Project	IEEE 802.16 Broadband Wireless Access Working Group < <a href="http://ieee802.org/16">http://ieee802.org/16</a> >	
Title	Key Hierarchy Text for PKMv2	
Date Submitted	2004-04-11	
Source(s)	David Johnston Intel Corporation 2111 NE 25 <sup>th</sup> Ave. Hillsboro 97124	Voice: +1 (503) 264-3855 <a href="mailto:dj.johnston@intel.com">[mailto:dj.johnston@intel.com]</a>
Re:	IEEE 802.16e	
Abstract	Proposal to introduce a key hierarchy to PKMv2	
Purpose	To create an well defined hierarchy for the storage and derivation of keys in PKMv2	
Notice	This document has been prepared to assist IEEE 802.16. It is offered as a basis for discussion and is not binding on the contributing individual(s) or organization(s). The material in this document is subject to change in form and content after further study. The contributor(s) reserve(s) the right to add, amend or withdraw material contained herein.	
Release	The contributor grants a free, irrevocable license to the IEEE to incorporate material contained in this contribution, and any modifications thereof, in the creation of an IEEE Standards publication; to copyright in the IEEE's name any IEEE Standards publication even though it may include

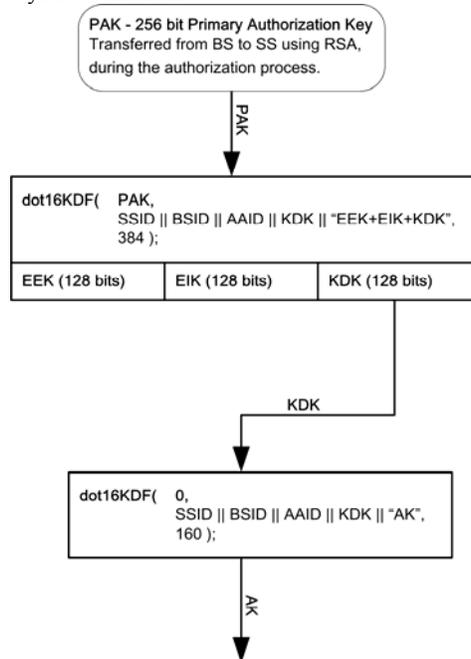
Figure xx outlines the process to calculate the AK when the authorization process has taken place, but where the EAP based authentication process hasn't taken place, or the EAP method used has not yielded an MSK:

Else if the authorization exchange has been used yielding a PAK and the EAP authentication exchange has been used, but with an EAP method that does not yield key material then the following AK construction shall be used:

$AK = \text{Dot16KDF}(0, \text{SSID} \parallel \text{BSID} \parallel \text{AAID} \parallel \text{KDK} \parallel \text{"AK"}, 160);$

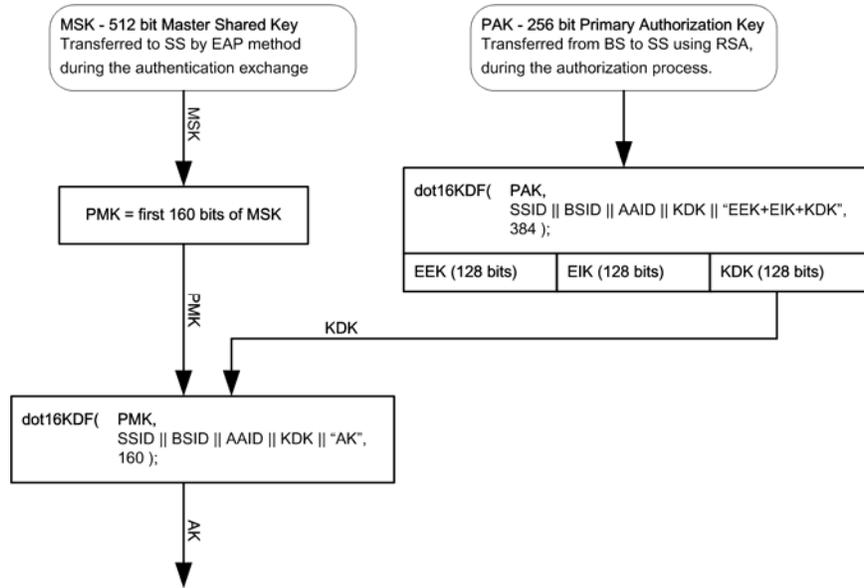
Figure xx outlines the process to calculate the AK when both the authorization exchange has taken place, yielding a PAK and the EAP based authentication exchange has taken place, yielding an MSK:

If the authorization exchange has been used yielding a PAK and the EAP authentication exchange has been used, yielding an MSK then the following AK construction shall be used:

$AK = \text{Dot16KDF}(\text{PMK}, \text{SSID} \parallel \text{BSID} \parallel \text{AAID} \parallel \text{KDK} \parallel \text{"AK"}, 160);$

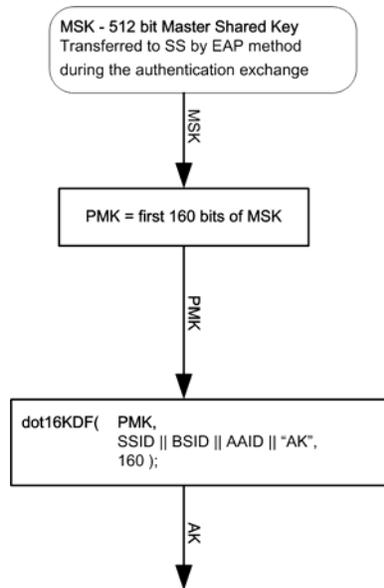
Figure xx outlines the process to calculate the AK when only the EAP based authentication exchange has taken place, yielding an MSK:

Else if only the EAP authentication exchange has been used, yielding an MSK then the following AK construction shall be used:

$AK = \text{Dot16KDF}(\text{PMK}, \text{SSID} \parallel \text{BSID} \parallel \text{AAID} \parallel \text{"AK"}, 160);$

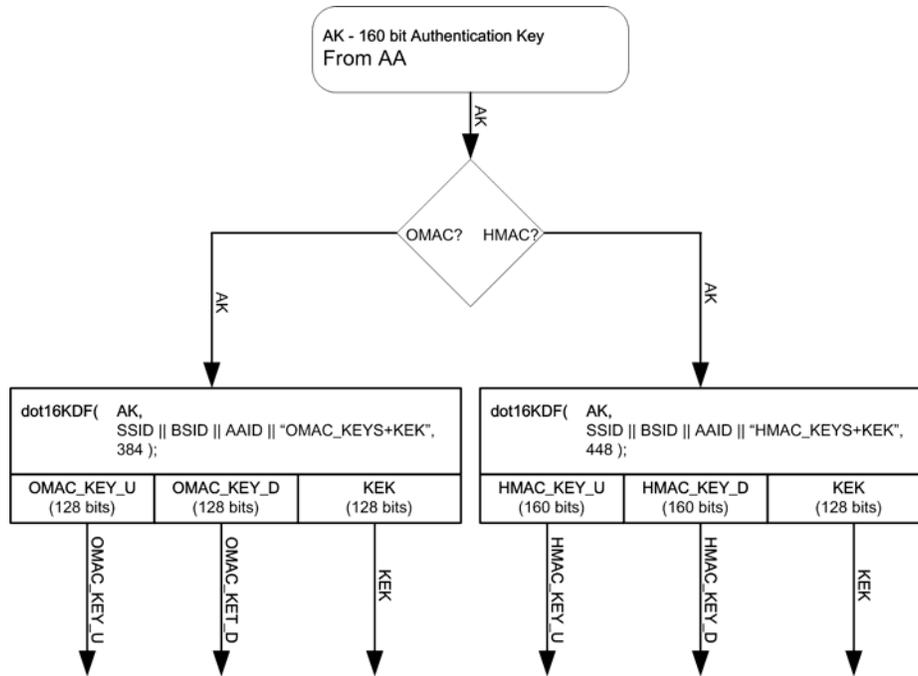
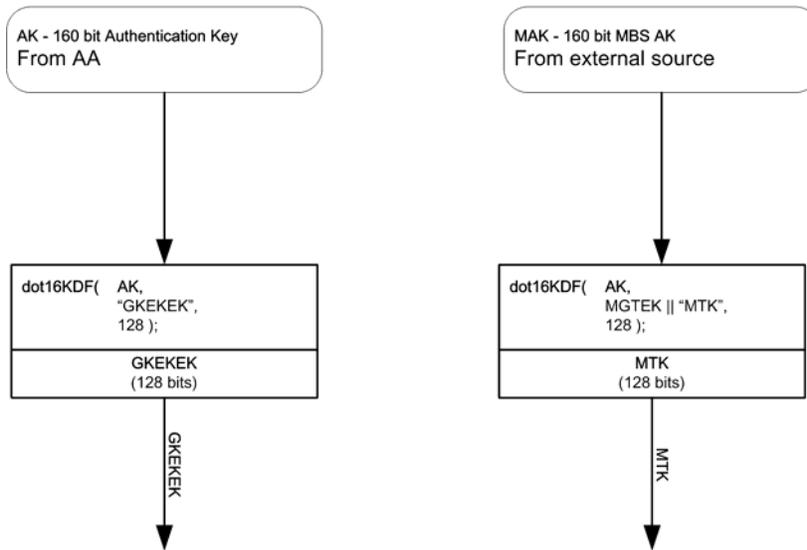
Figure xx outlines the unicast key hierarchy starting from the AK:

$\text{OMAC\_KEY\_U} \parallel \text{OMAC\_KEY\_D} \parallel \text{KEK} \leq \text{Dot16KDF}(\text{AK}, \text{SSID} \parallel \text{BSID} \parallel \text{"OMAC\_KEYS+KEK"}, 384)$   
 $\text{HMAC\_KEY\_U} \parallel \text{HMAC\_KEY\_D} \parallel \text{KEK} \leq \text{Dot16KDF}(\text{AK}, \text{SSID} \parallel \text{BSID} \parallel \text{"HMAC\_KEYS+KEK"}, 448)$

The TEK is passed from the BS to the SS in a TEK exchange. It is encrypted using AES\_KEY\_WRAP, using KEK as the key.
